SUBJECT: NORTHERN STATES POWER COMPANY, Prairie Island Nuclear Generating  
Plant, Unit Nos. 1 and 2

SAFETY EVALUATION BY THE OFFICE OF NUCLEAR REACTOR REGULATION

RELATED TO EXEMPTIONS FROM 10 CFR 50, APPENDIX R

PRAIRIE ISLAND NUCLEAR GENERATING PLANT UNITS 1 AND 2

Figure 1. Scaled Heat Flux versus Scaled Forced Ventilation Rate

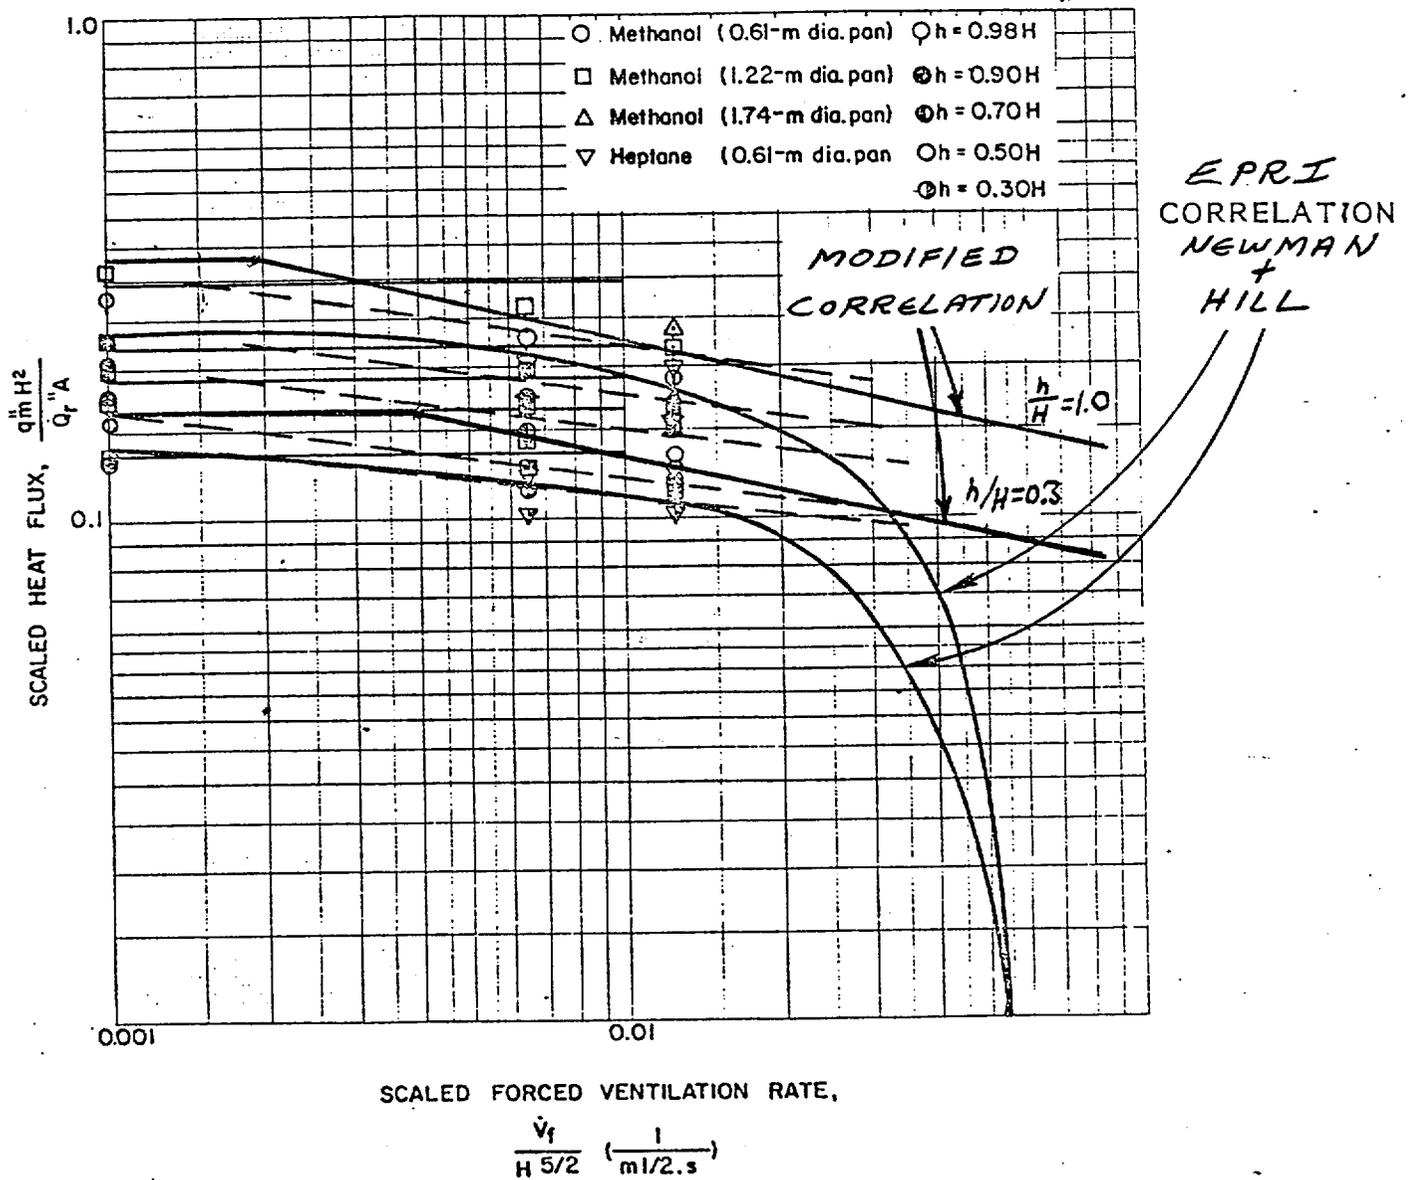
The submittal does not use the Newman and Hill correlation exactly as presented in reference 1. Instead a modified form as given on page A.2-4 is used. Apparently, this was done to extend the correlation at ventilation rates greater than those for which measurements were taken in reference 1. This fact, coupled with the unrealistic cooling behavior of the original Newman and Hill correlation at higher ventilation rates as shown in Figure A.2-2 leads to the need for the modified correlation, which continues the data trend to higher values of ventilation. This modified correlation is more conservative than the original. Since the labeling of Figure A.2-2 is somewhat confusing, it is replotted as Figure 1 (attached) with the modified correlation on page A.2-4 included.

Several questions are therefore raised in applying the Newman-Hill correlation in the context of a stratification model, viz.,
